Title: Ward Water Treatment Plant Upgrades
Wharton & Smith – Change Order No. 004

Change Order No. 004

Project: Ward WTP Upgrades	Owner: The City of High Point	Owner's Contract No.: Bid #56-082218
Contract: Ward Water Plant Upgrades	Date of Contract: 18-SEP-2018	
Contractor: Wharton Smith Inc.	Engineer's Project No.: 190221

**Subject: Ward Water Treatment Plant Upgrades Project
Change Order #4 Descriptive Narrative**

Figure (2)

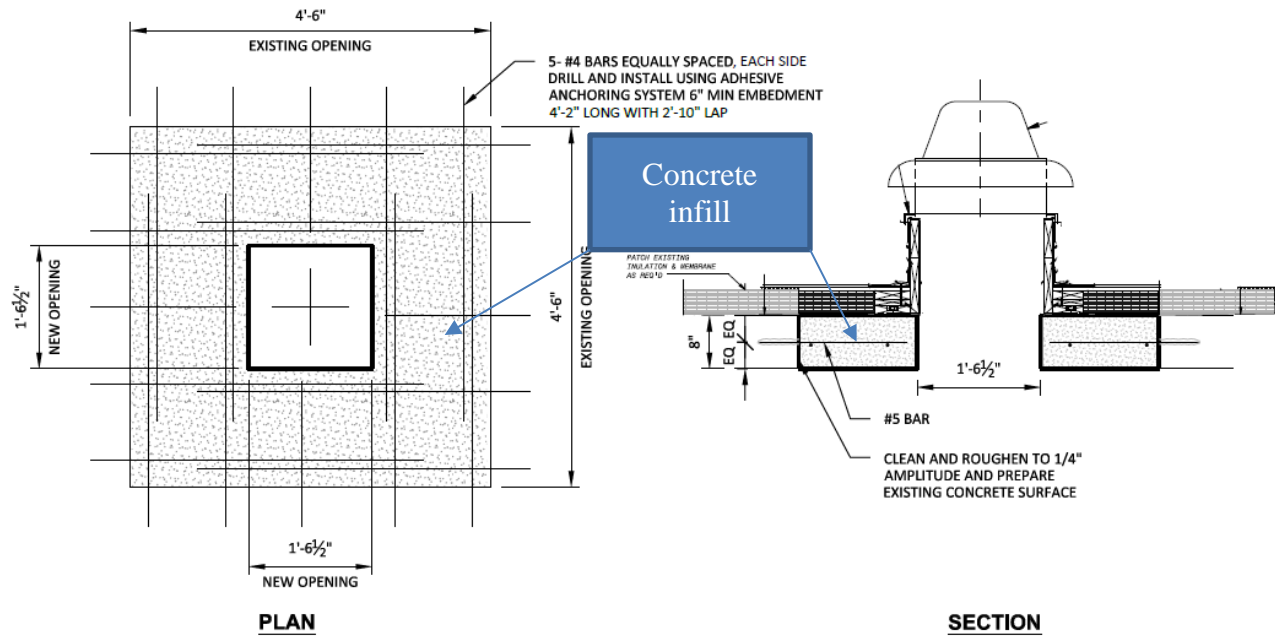
Added Emergency Back-Up Generator for the Shutdown on September 29-30, 2019.

Item #2 – Added Emergency Back-Up Generator for the Shutdown on September 29 and 30, 2019 for an additional cost of \$45,501.00, and no time extension.

The scope of additional work requested by the City includes providing one additional 2 MW Emergency Standby Generator as secondary backup to provide temporary power to energize the existing 2.4kV Switchgear in case the first emergency generator fails to operate or malfunction. The additional scope of supply also includes all cable and accessories required for switching over between the two emergency generators to the transformer, all transportation to and from the site for this additional equipment, as well as all require startup and testing personnel and additional field staff to provide continuous operational and switchover supervision in case of an equipment failure.

Figure (3)

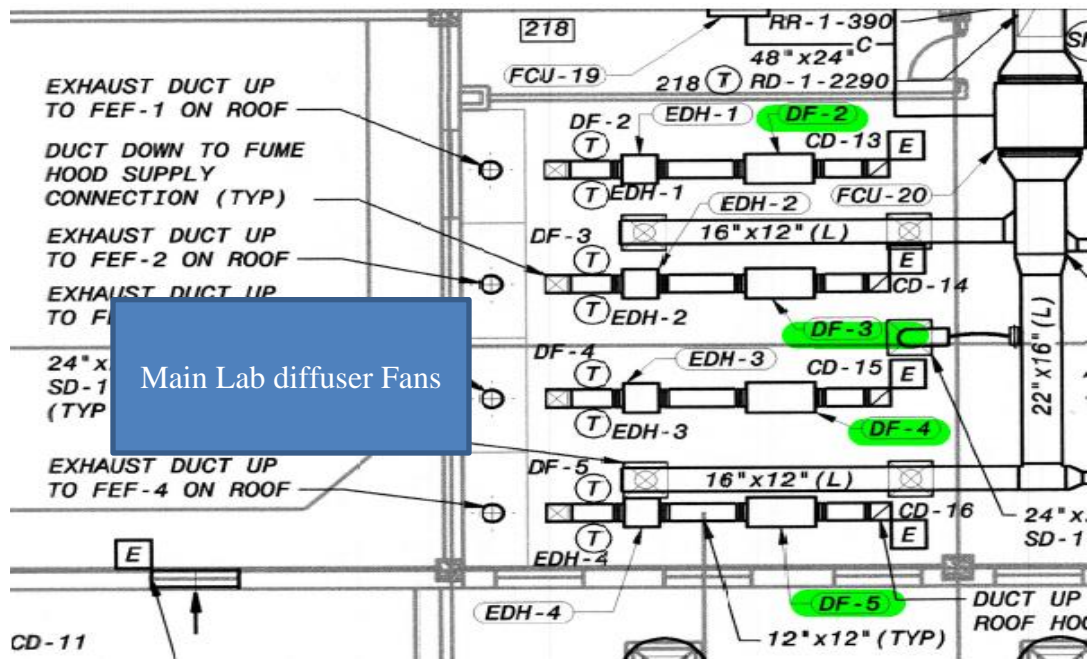
Added concrete infill to reduce size of existing roof penetrations.

Item #3 – Added concrete infill to reduce size of existing roof penetration from 54"x54" to 24"x24" for an additional cost of \$1,827.00, and no time extension.

During initial installation, the Contractor discovered that the existing roof slab opening was larger than the opening dimensions needed for the new PRV-9. In order to reduce the size of the existing roof opening, the Contractor was required to form up the opening, secure additional steel reinforcement by means of drilling and adhesive anchors such rebar to the existing roof slab, pour the necessary concrete infill, and once properly cured proceed to strip the installed formwork.
